LINCOLN CITY/LANCASTER COUNTY PLANNING STAFF REPORT

P.A.S.: Preliminary Plat #01016
Special Permit #692L

PROPOSAL: To develop 36 units of single- and two-family elderly or retirement housing within the Tabitha New Community C.U.P.

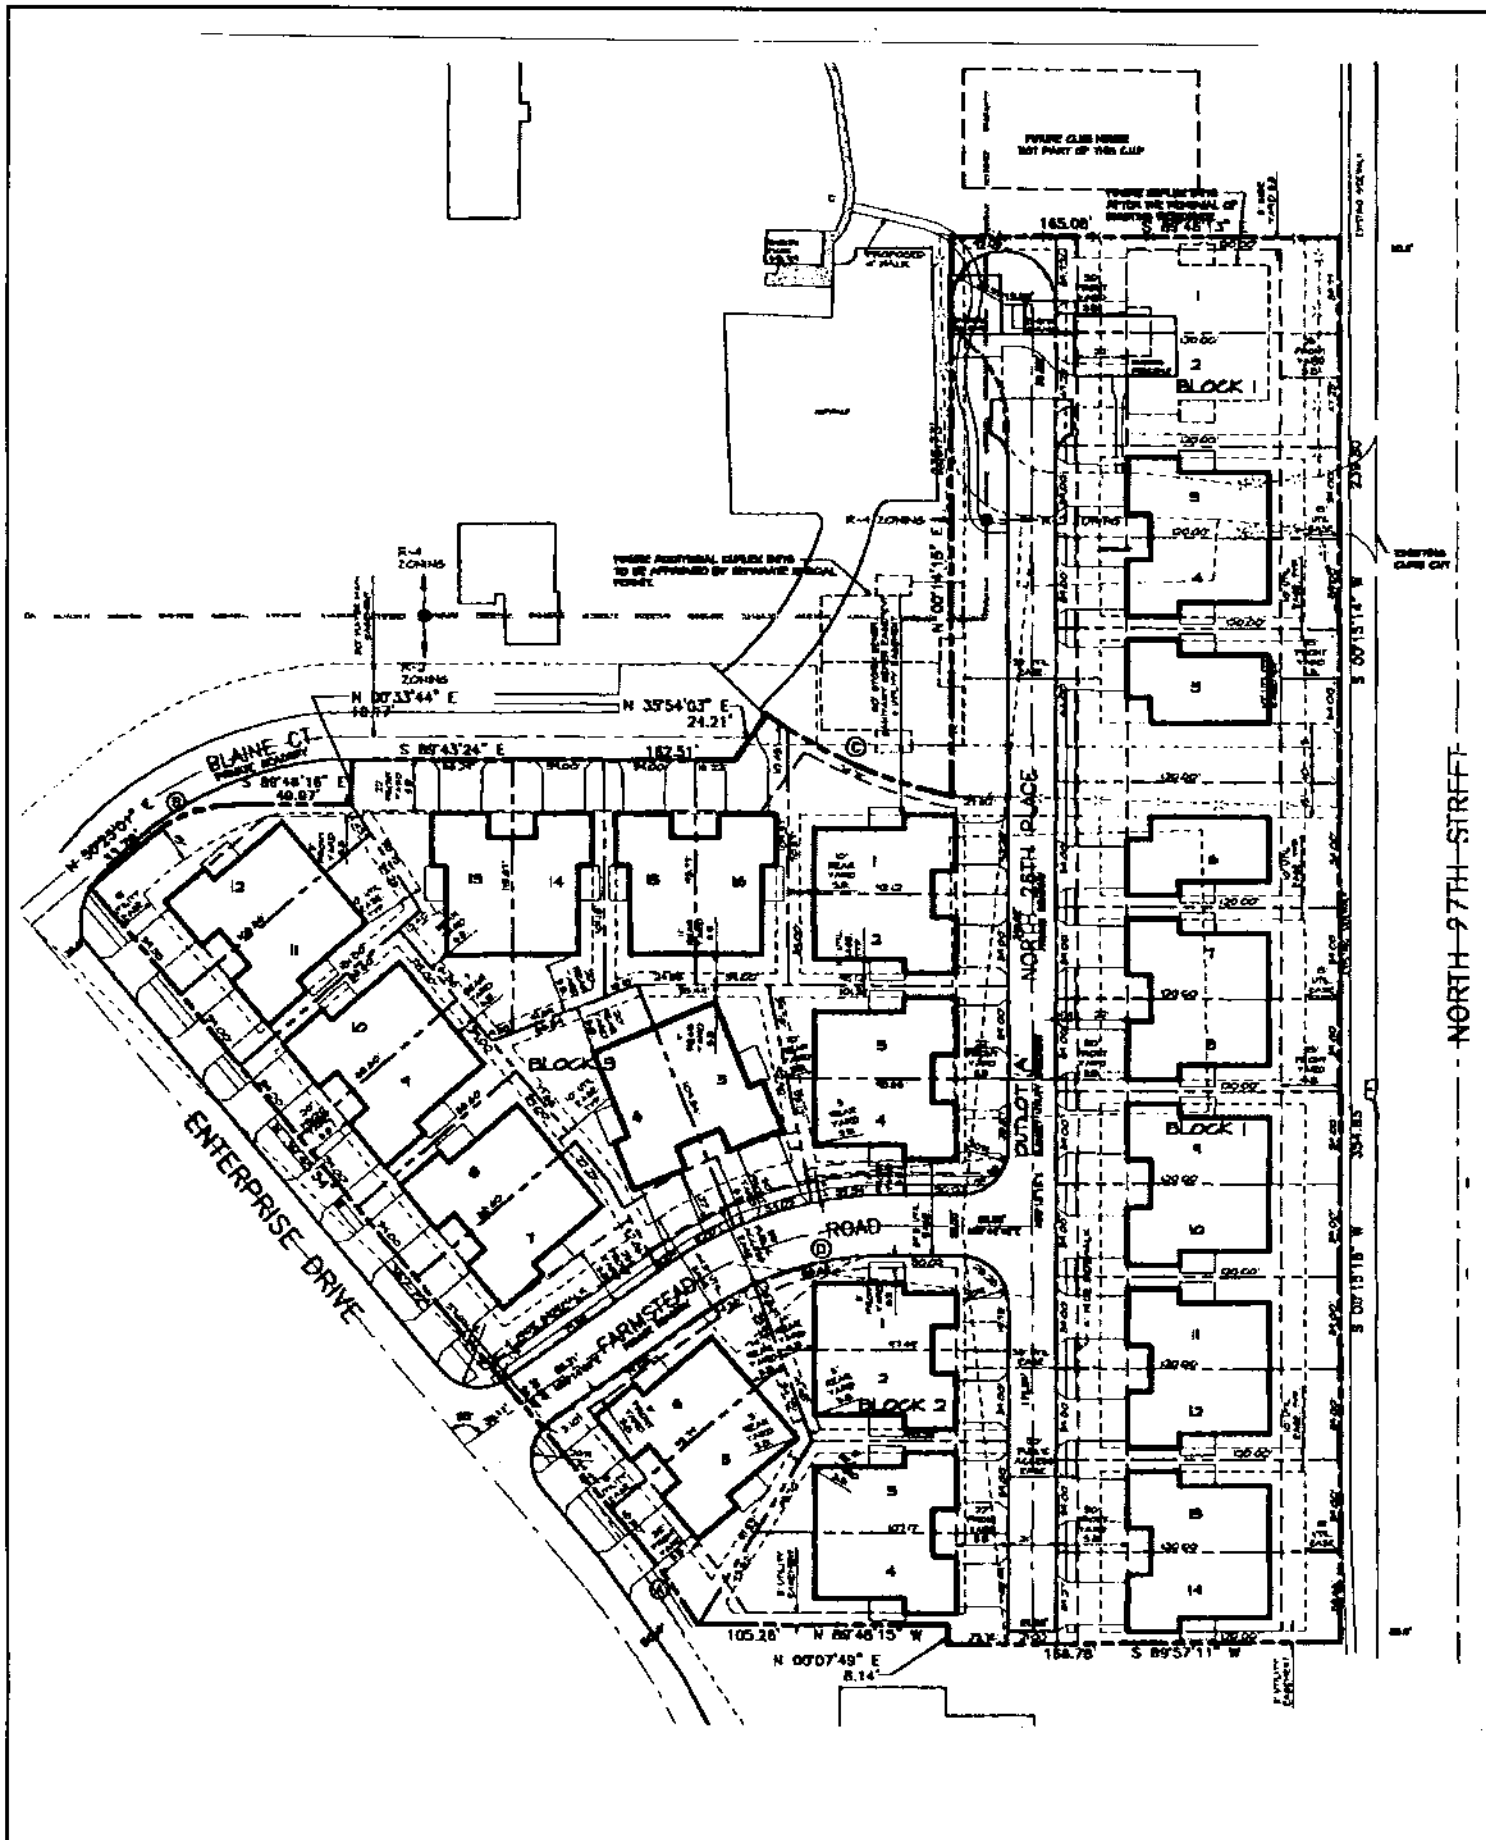
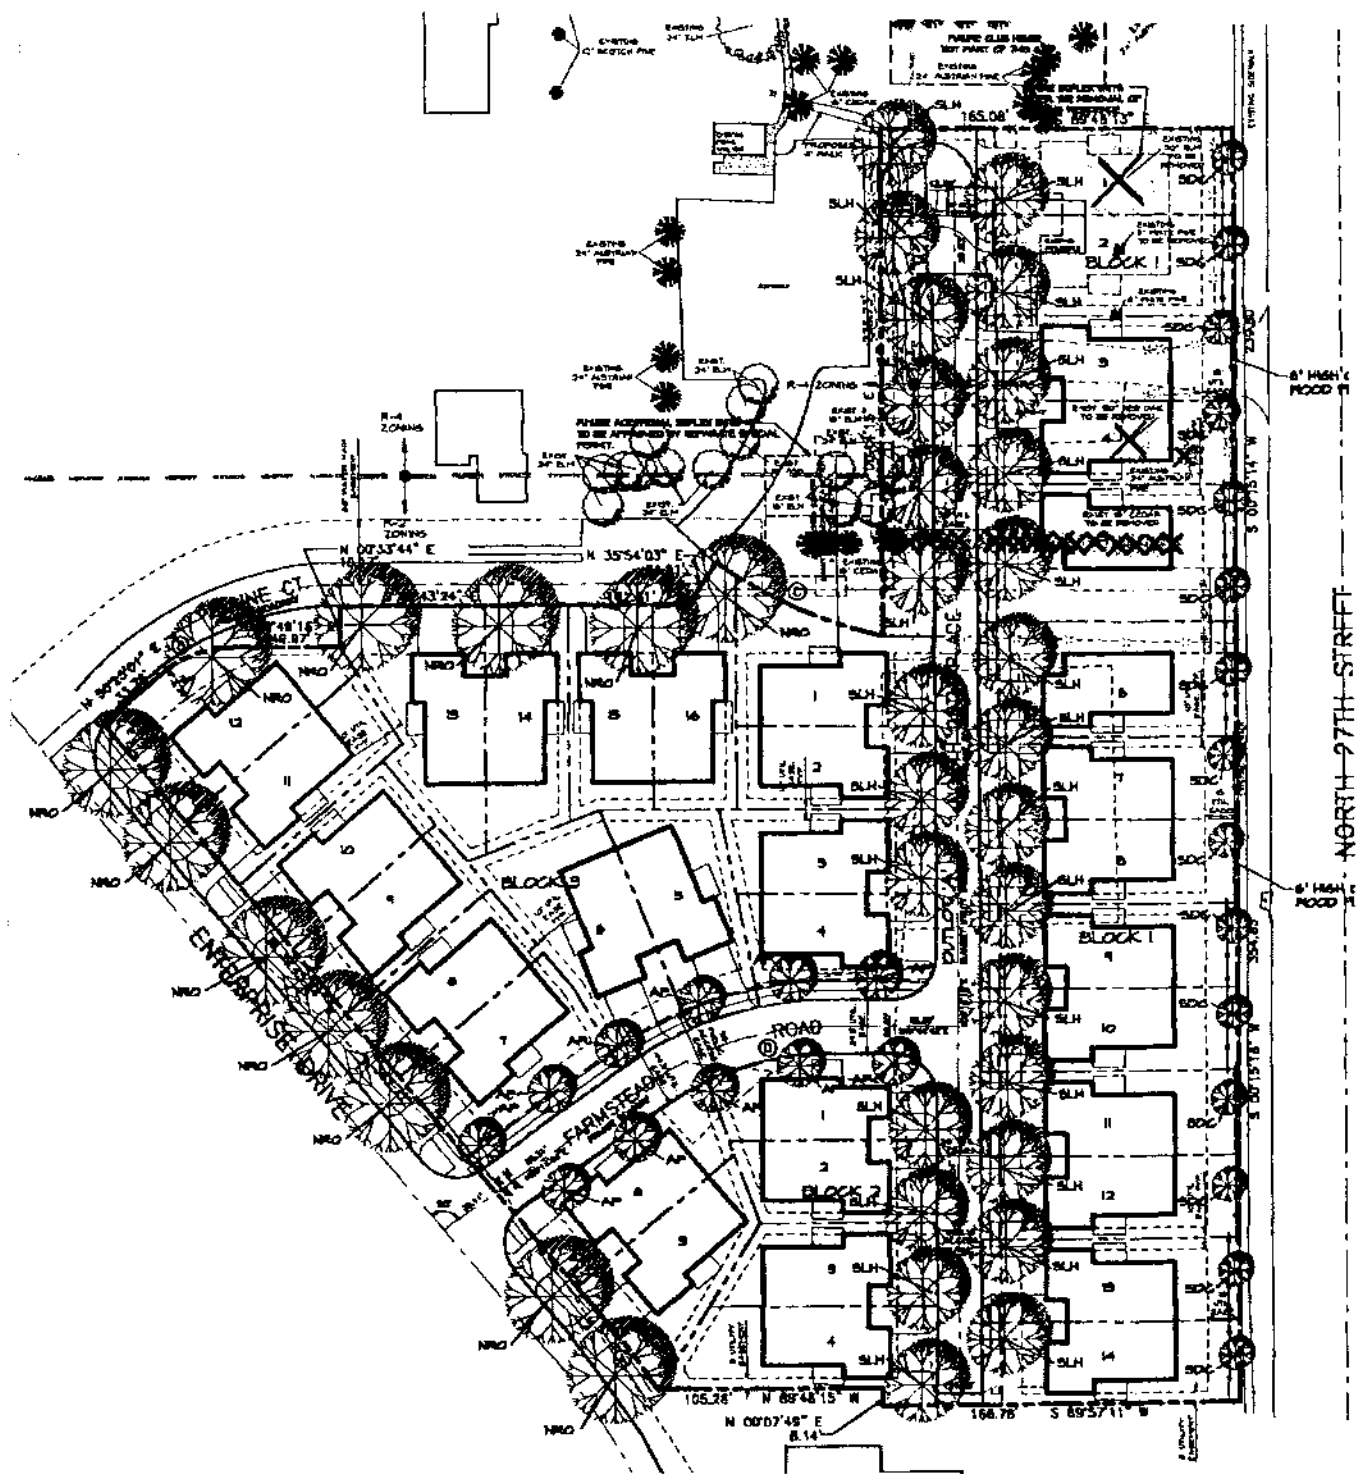
The request to waive sidewalks on one side of the private roadways is not appropriate; sidewalks will promote pedestrian circulation and provide access to the Tabitha recreation facilities.

2. The houses in Blocks 2 and 3 are tightly grouped. This arrangement, which results in minuscule yards, would not normally be acceptable. For elderly or retirement housing, reduced yards can be appropriate. In this case, none of the houses should be more than one story tall.

3. Sidewalks are required by the Subdivision Ordinance, and this development is not of such an unusual size, shape, or character that waiving them is necessary. If this development is to take advantage of the Tabitha recreation facilities, it must have good pedestrian linkages to those facilities.

5. On some lots, buildings could potentially fill most of the open space shown on the plan. The drawings should identify a building envelope in addition to the yards.

6. Opaque fences should be prohibited in Blocks 2 and 3. If the relatively small amount of open space were partitioned by fences, some of the rear yards would become uninhabitable.

- 1.1 Revise the preliminary plat to show:
 - 1.1.1 Sidewalks on both sides of the streets and private roadways.
 - 1.1.2 Easements as requested by L.E.S.

- 1.1.3 Revise the proposed 4' walk on the north end of N. 26th Place so that it does not go through the turnaround.
 - 1.1.4 To the legal description, add "a portion of vacated Farmstead Rd".

- 1.1 Revise the site plan to show:
 - 1.1.1 Provide density calculations on the site plan.
 - 1.1.2 A sidewalk connection from Blaine Court to N. 26th Place.

- 1.1.3 Add a note to the site plan indicating that no structure on Block 2 or 3 shall be more than one story in height.
 - 1.1.4 Add a note to the site plan indicating that decks and patios shall not be enclosed or covered if they are within front, rear or side yard setbacks.

- 1.1.5 Provide a lot area table.
 - 1.1.6 Dimension the setback on the northwest corner of Lot 12, Block 3.
 - 1.1.7 Add a note indicating that opaque fences are prohibited in Blocks 2 and 3.

- 1.1.8 Dimension building envelopes rather than setbacks.
2. This approval permits 36 units of elderly or retirement housing within the Tabitha New Community C.U.P., provided that the City Council permits the following modifications:
